**MCPB
Item #
09/21/06**

REVIEW TYPE: Preliminary Plan of Subdivision, Resubdivision of existing Lot 19, Block 8, Tilden Woods

PROJECT NAME: Tilden Woods

CASE #: 120060220

PRELIMINARY PLAN OF SUBDIVISION
PROPOSED LOTS 32 & 33 - BLOCK B
TILDEN WOODS

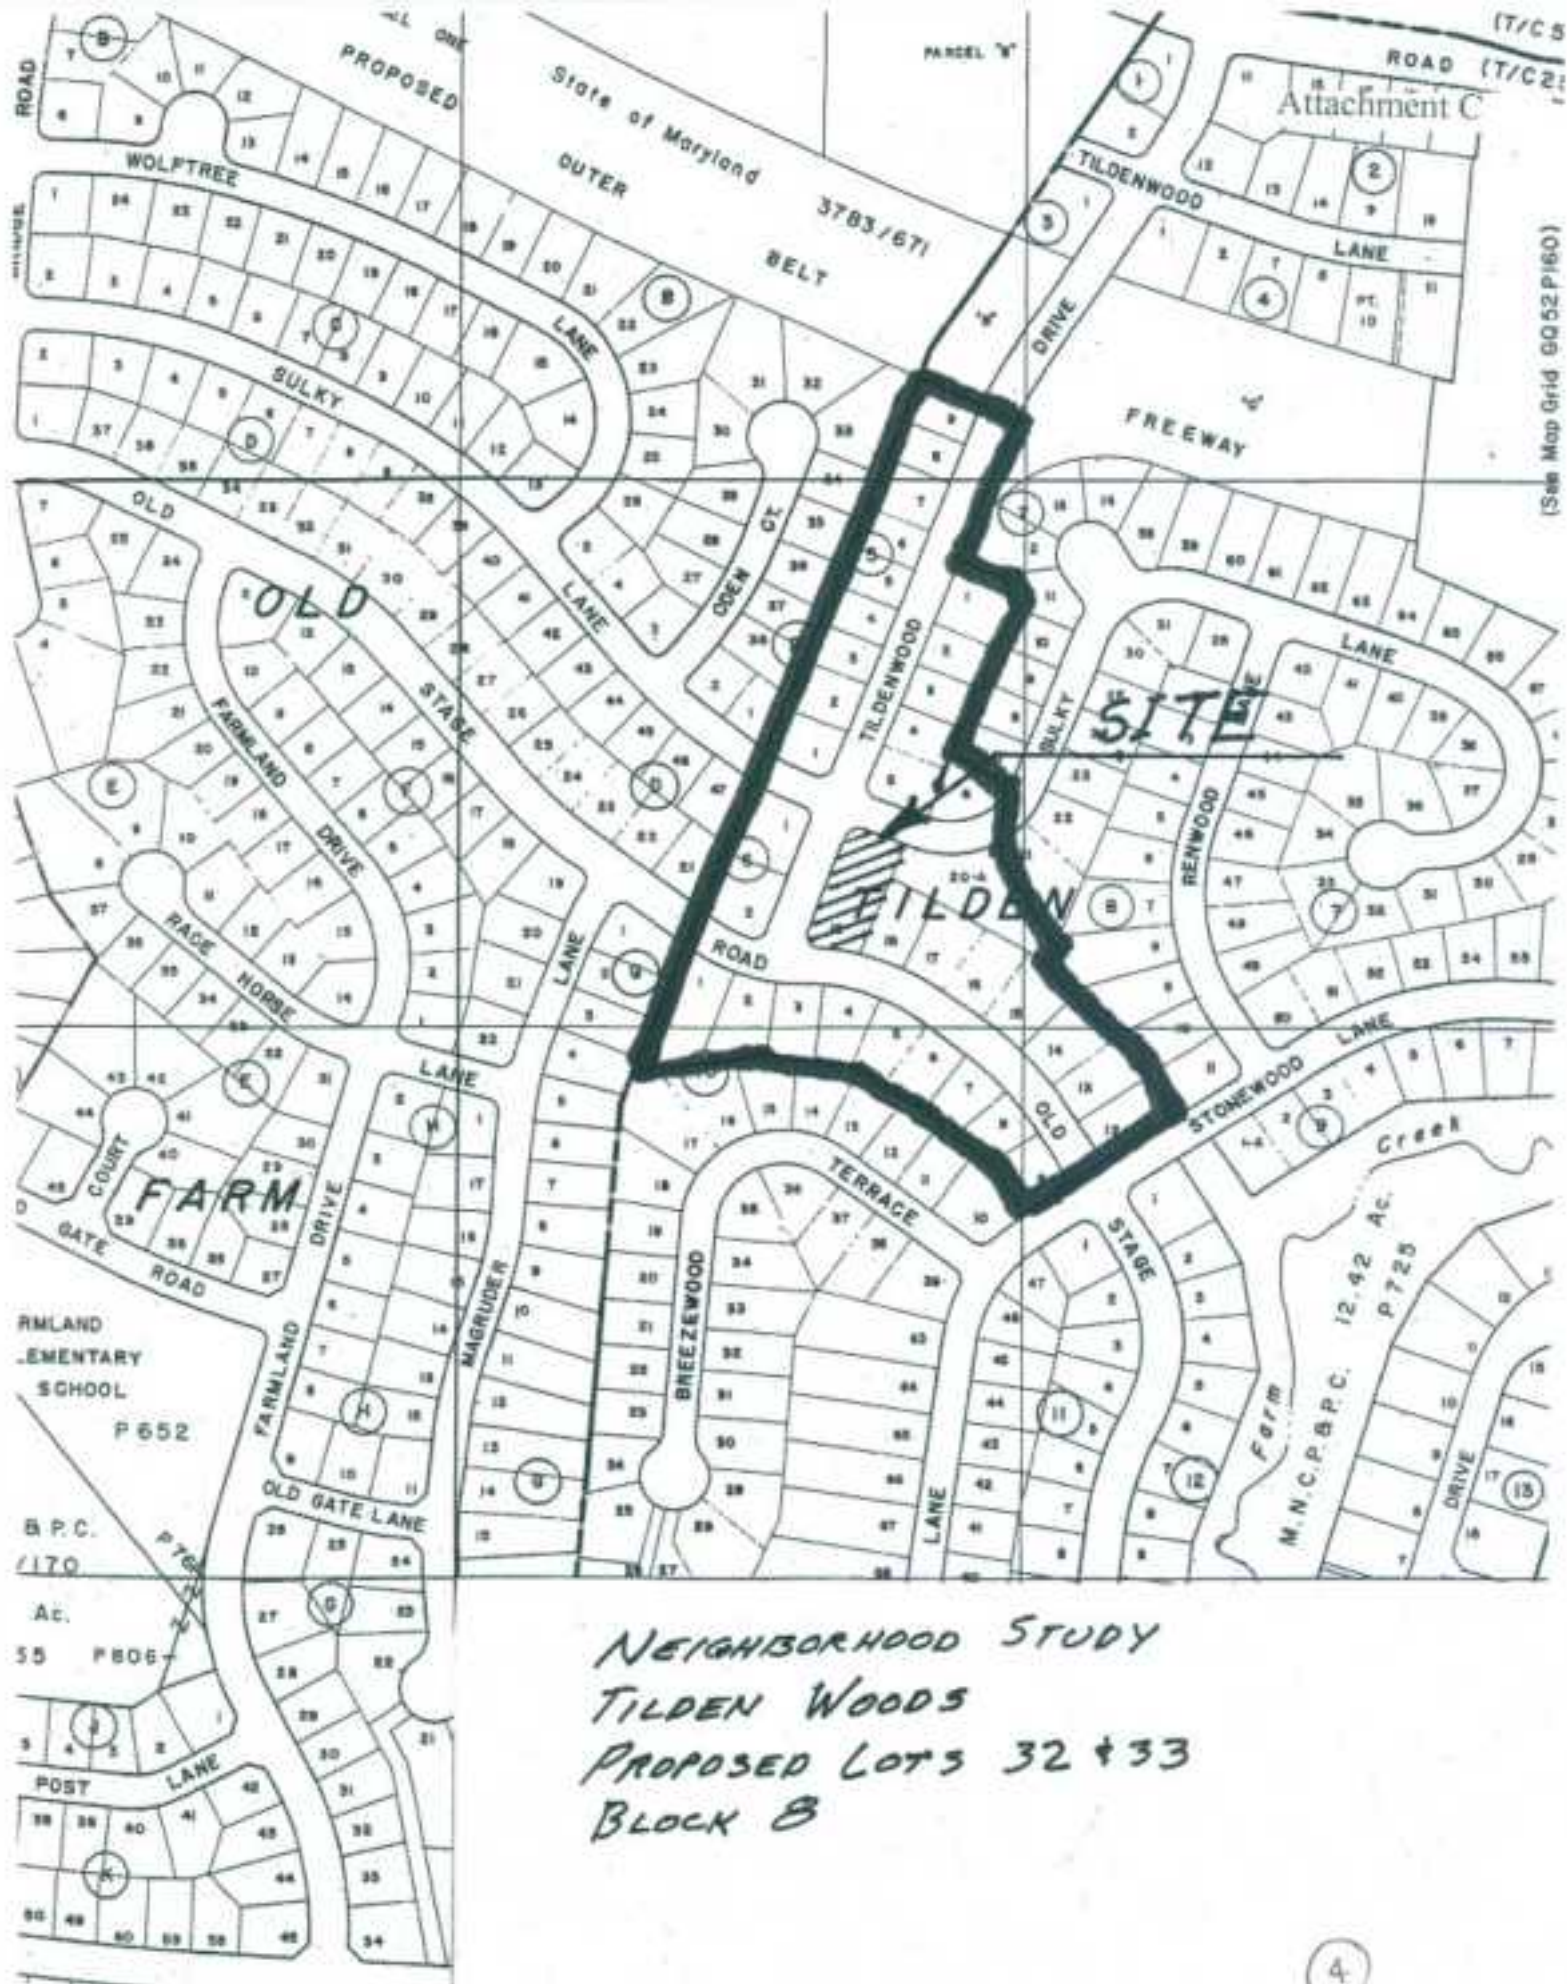
We have completed our review of the preliminary plan dated August 17, 2005. This plan was reviewed by the Development Review Committee at its meeting on September 26, 2005. We recommend approval of the plan subject to the following comments:

1. Grant necessary slope and drainage easements. Slope easements are to be determined by study or set at the building restriction line.
2. The sight distances study has been accepted. A copy of the accepted Sight Distances Evaluation certification form is enclosed for your information and reference.
3. In accordance with Section 49-35 (e) of the Montgomery County Code, sidewalks are required on Sulky Lane to serve the proposed subdivision.
4. Relocation of utilities along existing roads to accommodate the required roadway improvements shall be the responsibility of the applicant.

- A. Construct a four (4) foot wide concrete sidewalk across the Sulky Lane site frontage to connect with the existing sidewalk on Tildenwood Drive. Provide a handicap ramp at the intersection of Sulky Lane and Tildenwood Drive.
